Project Title:	Wyvols Court Farm
Project No/ Document Reference:	HD215-R004
Date:	29 April 2026
Author:	Andrew Lovegrove / Nick Billingham

RESPONSE TO WOKINGHAM BOROUGH COUNCIL HIGHWAY COMMENTS

Title
**SWEPT PATH ANALYSIS
REFUSE VEHICLE**

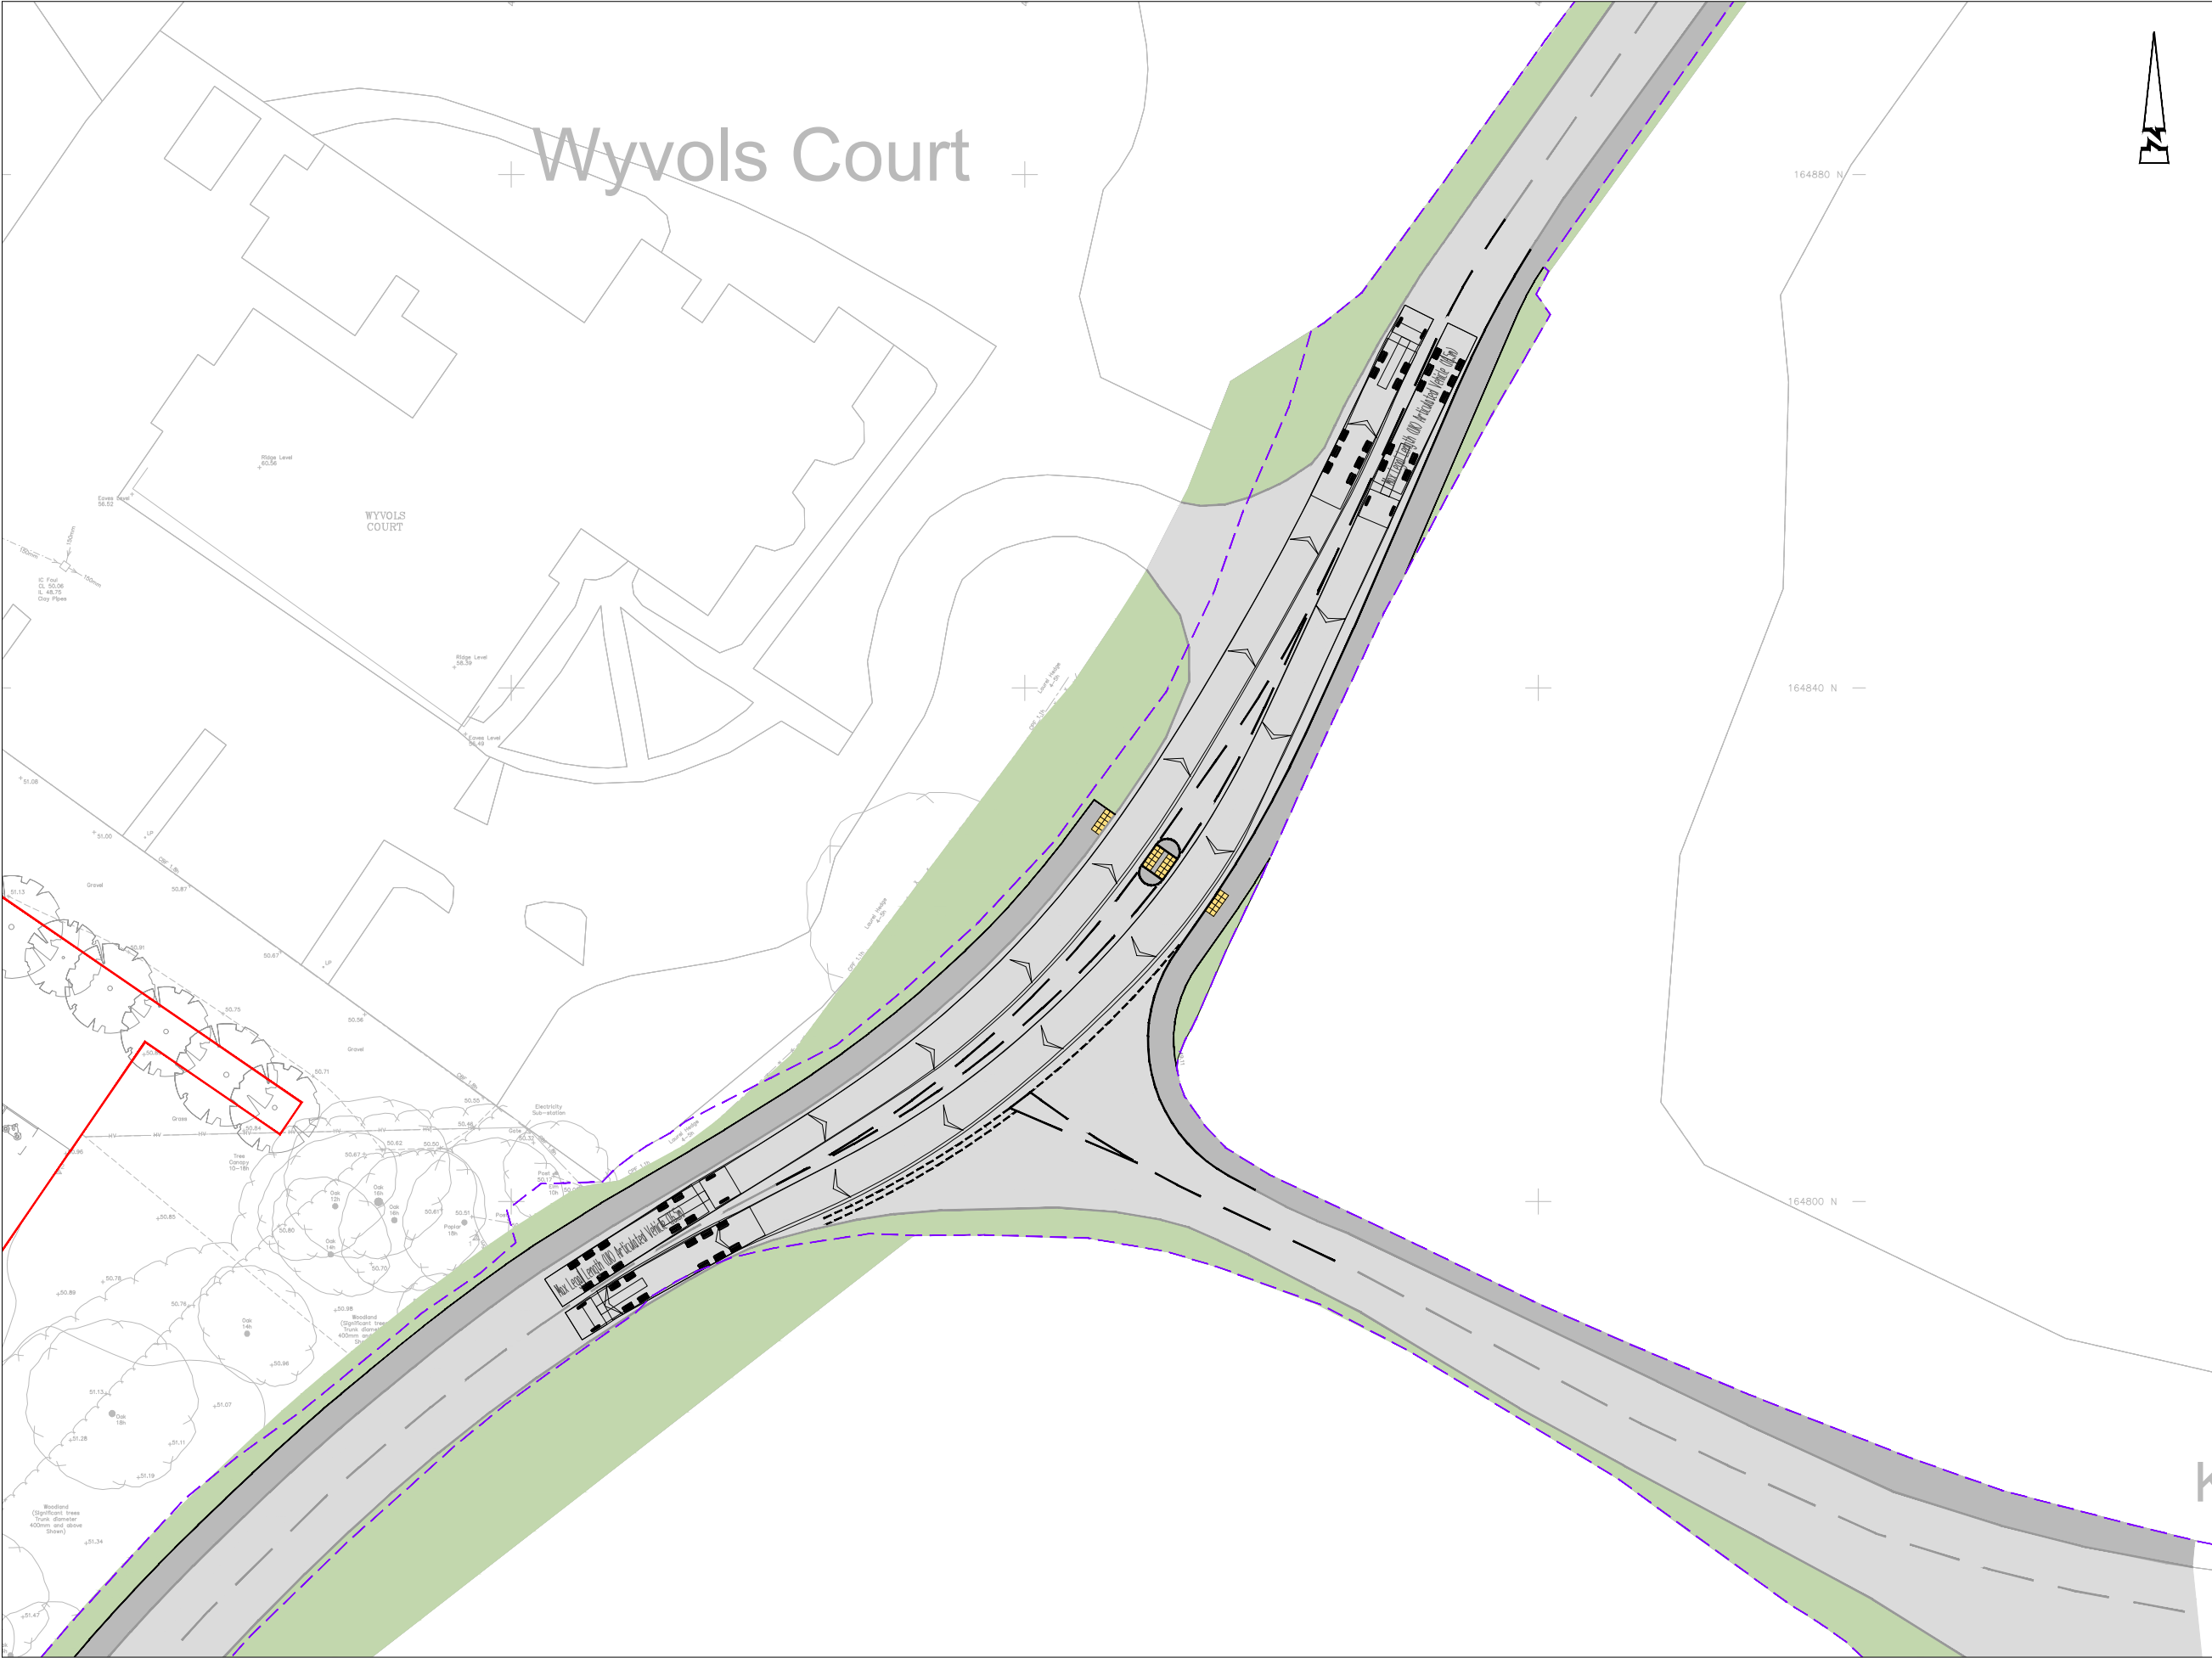
- The Highways assume the existing commercial waste collection arrangement remain suitable for this proposal.
- Subject to the revised reversing distance to be less than 12m, the Highways can consider the proposed swept paths for HGV to be a proxy of refuse vehicles.

Subject to the revised reversing distance to be less than 12m, the Highways can consider the proposed swept paths for HGV to be a proxy of refuse vehicles.

- 1.9.2 Drawing **HD215-003 A** included within **Appendix D** demonstrates each of the units can be serviced by a large refuse vehicle as per the requirements set out within the WBC waste collection policy.
